654.1015
Job Sheet 216587

Part Name: Doubler

Note: DWG 654.1000 REV N/C IPP REV:A NEW ISSUE 14/12/20 JLM VERIFIED BY:DD

SHEETMETAL BRACKET

SEE	CAGE CODE	DWG. NO.	REV.
B	07/M26	654.1000	N/C
SCALE	NONE	SHEET	1 OF 4

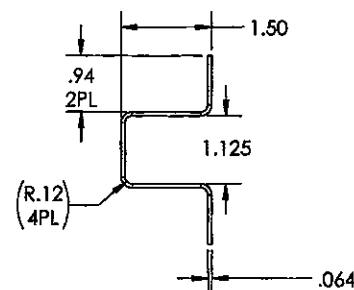
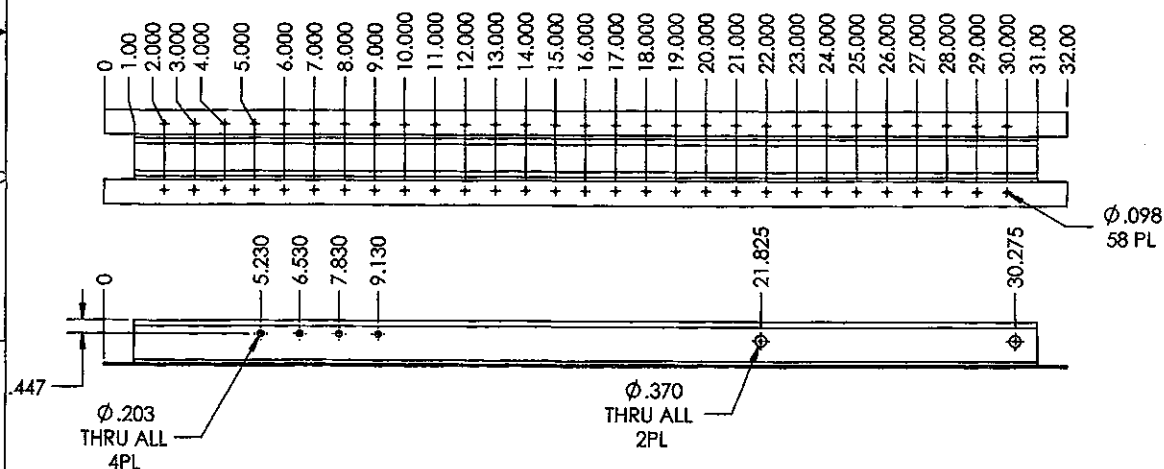
Hi David, from the models I see that the holes for the 654.1014 are 0.170" dia, and the holes in the 654.1015 are 0.098" dia.

Hi Alex,
On Dwg 654.1000, missing hole dimension on 654.1014 and 654.1015.

I'll have to submit an ECR to update the drawing. Not sure how fast it'll take to get that updated.
Alex
